ADDENDUM NO. 01

RANKIN TRAILS AMPHITHEATER AND BASEBALL PARK

Rankin County, Mississippi

WBA Proj. # 2215/2315

S3.1
ELEVATIONS

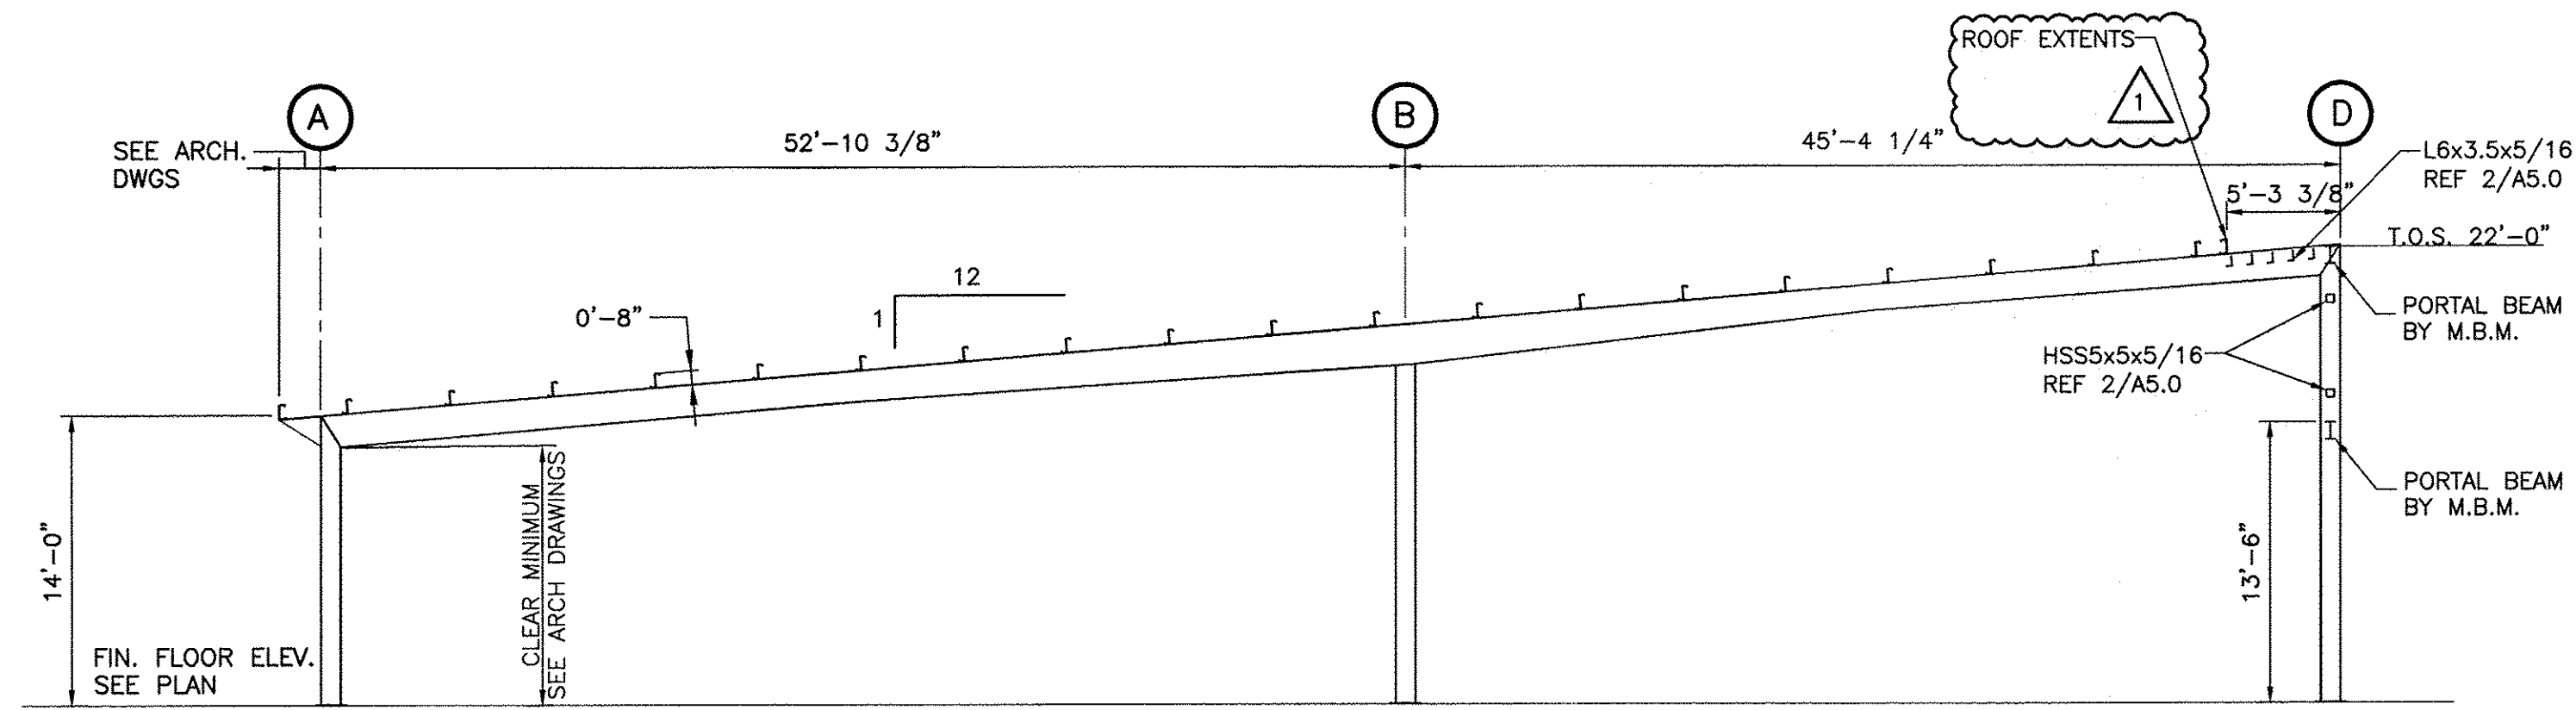
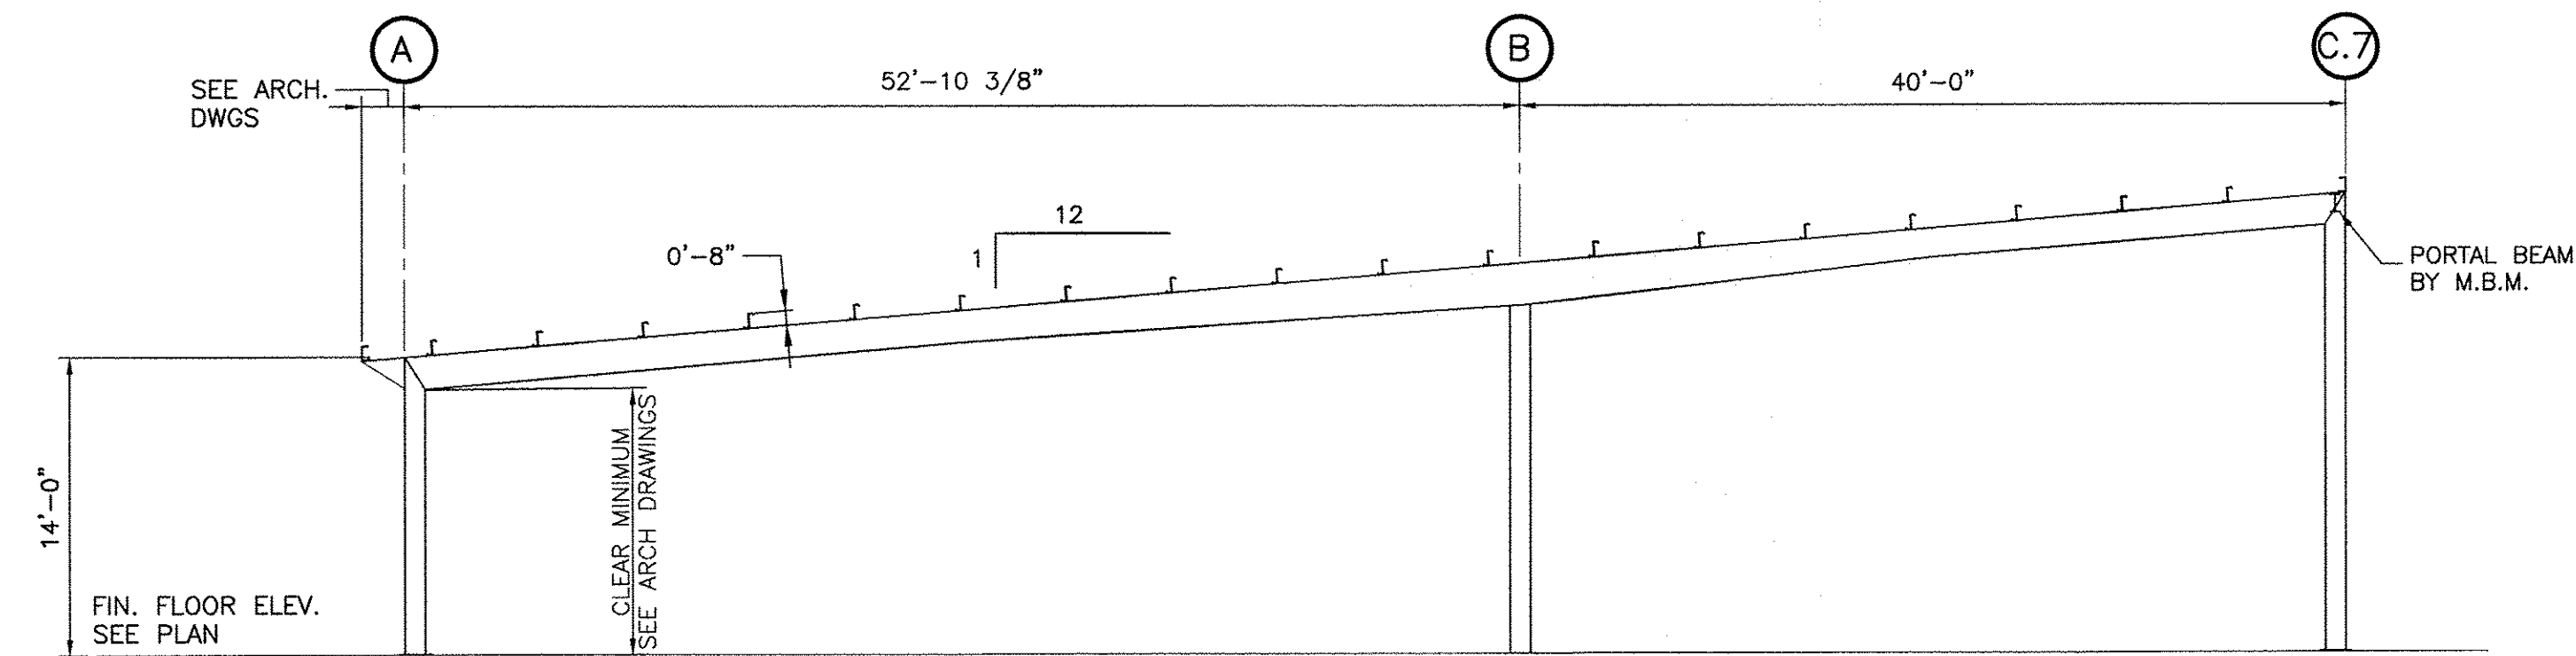
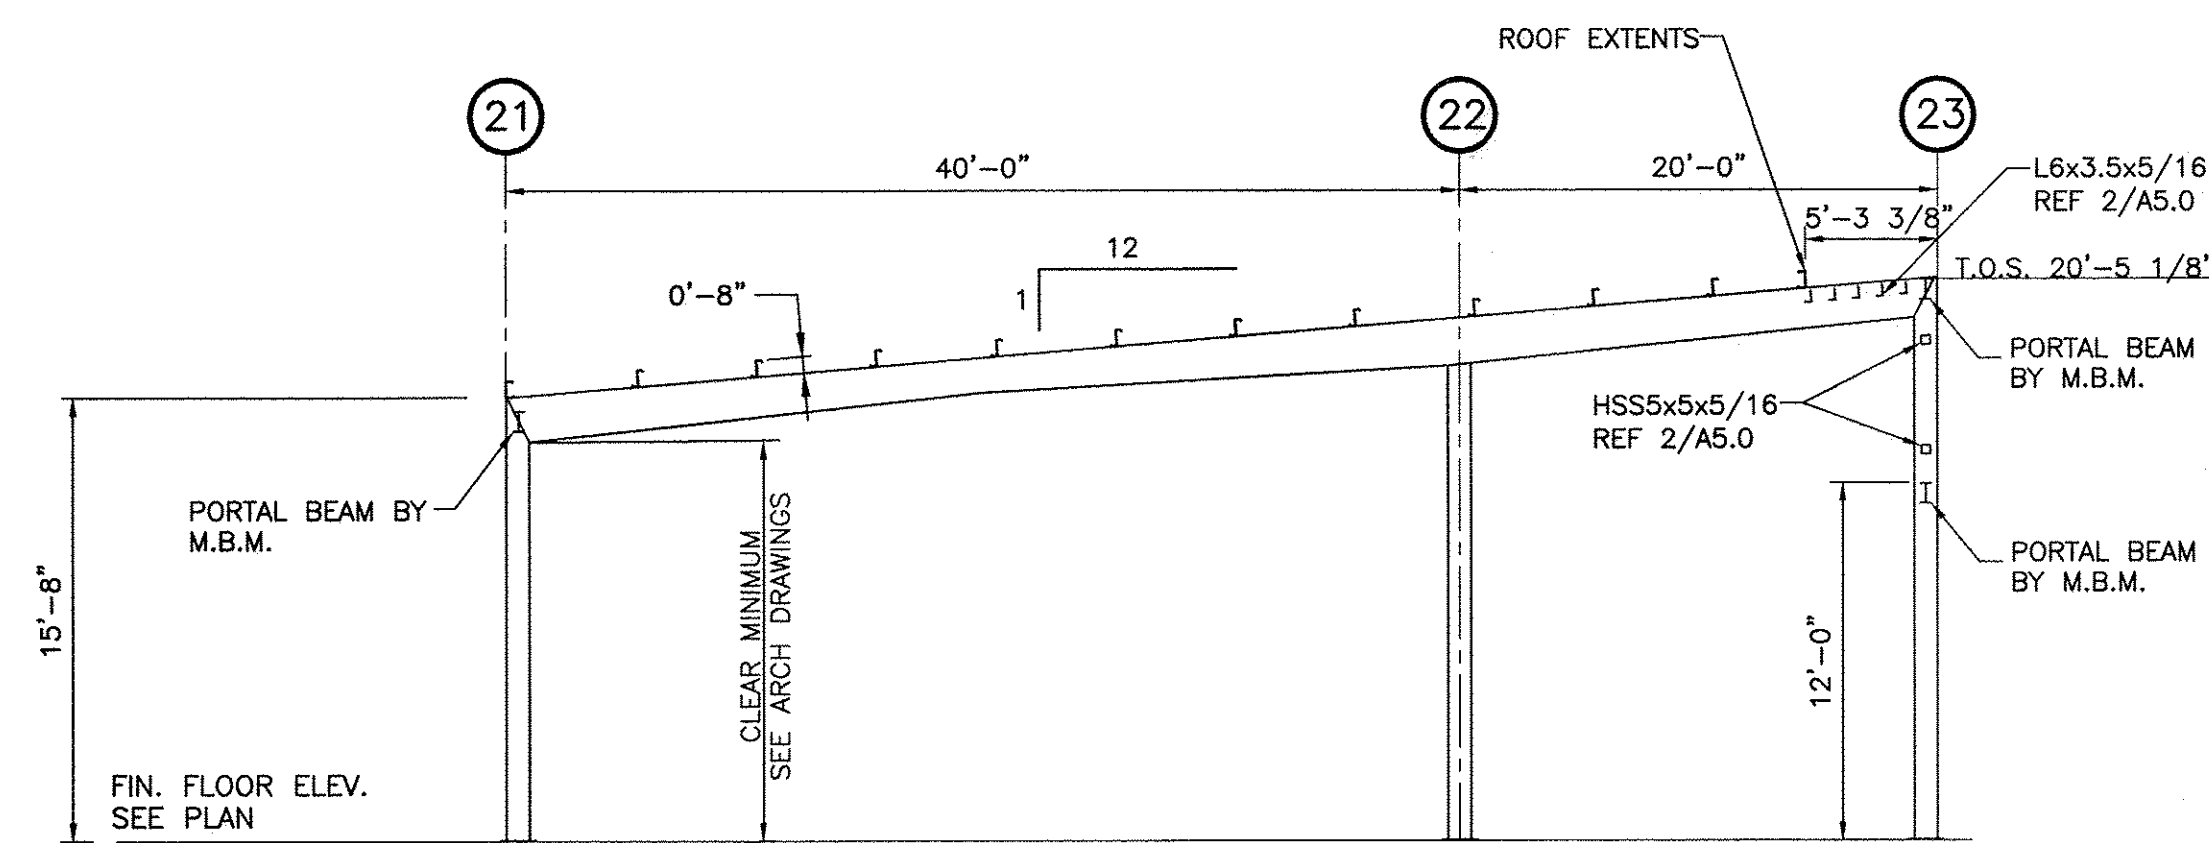
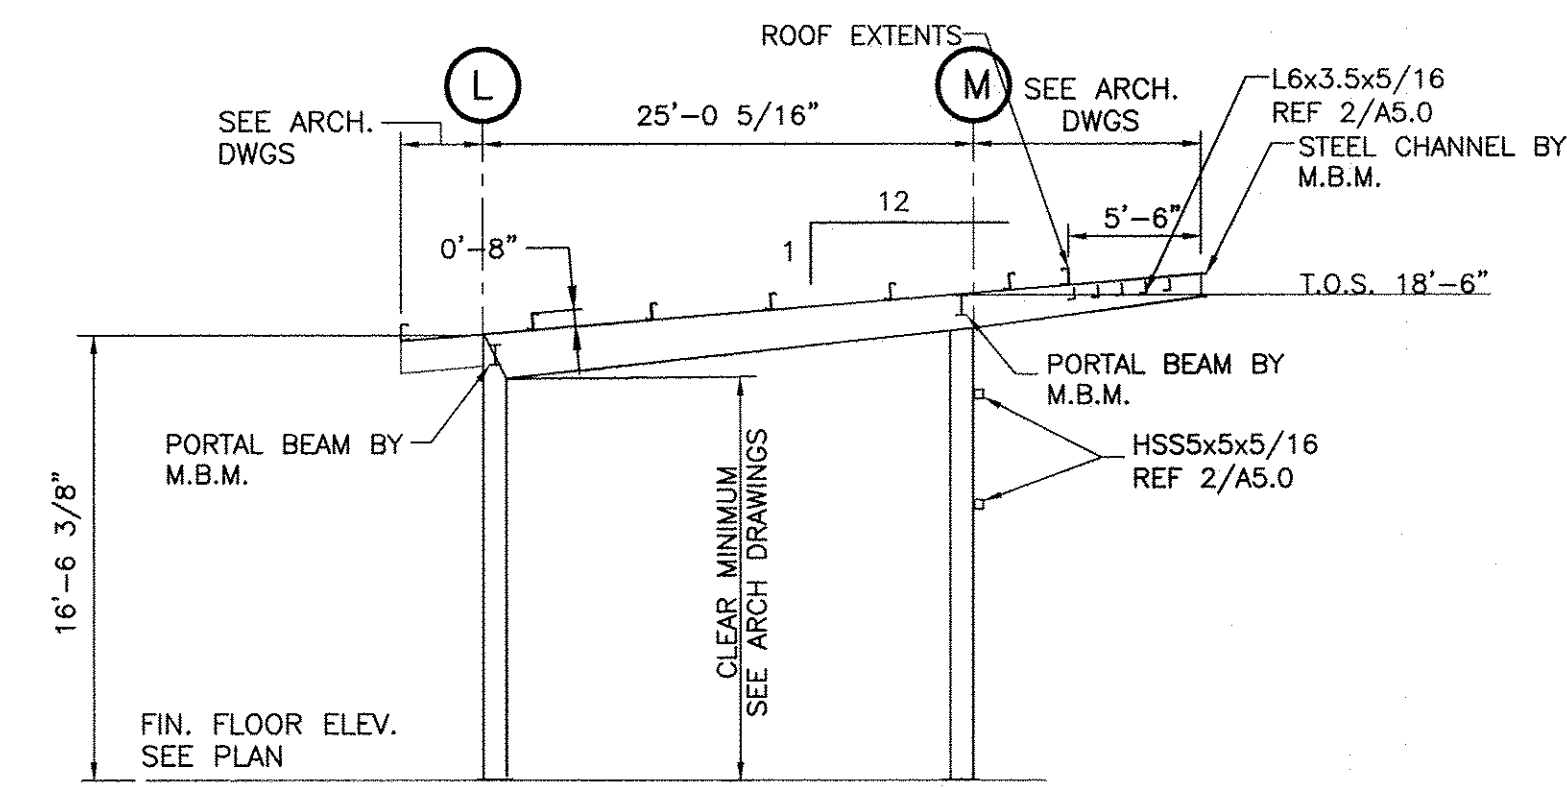
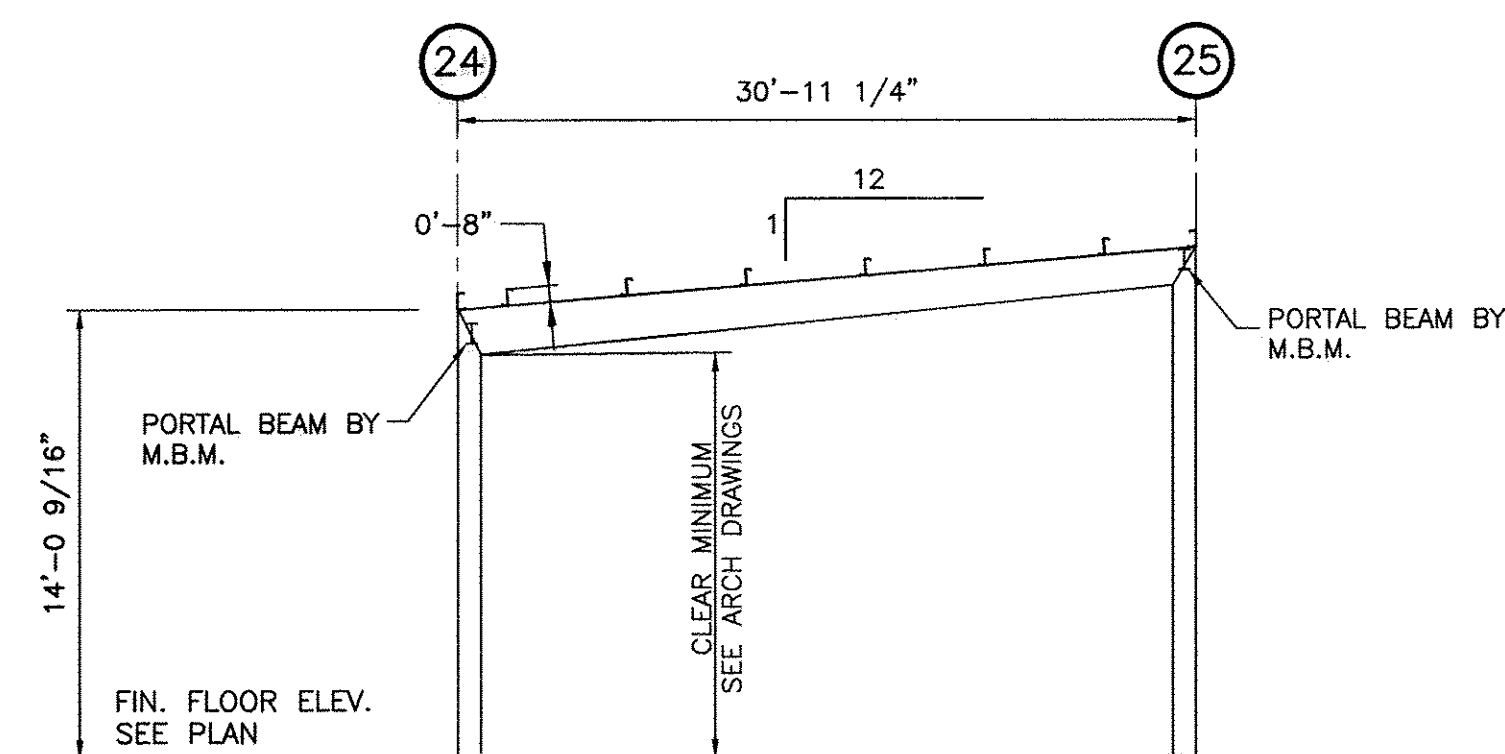
- ITEM NO. 15** **SHEET S3.1 ELEVATIONS**
ADD missing text, per enclosed revised sheet S3.1.
- ITEM NO. 16** **SHEET S4.3 SECTIONS**
REVISE wall reinforcement extents, per enclosed revised sheet S4.3.
REVISE wall reinforcement, per enclosed revised sheet S4.3.
REVISE embedded bolt size and depth, per enclosed revised sheet S4.3.
ADD roof deck detail, per enclosed revised sheet S4.3.
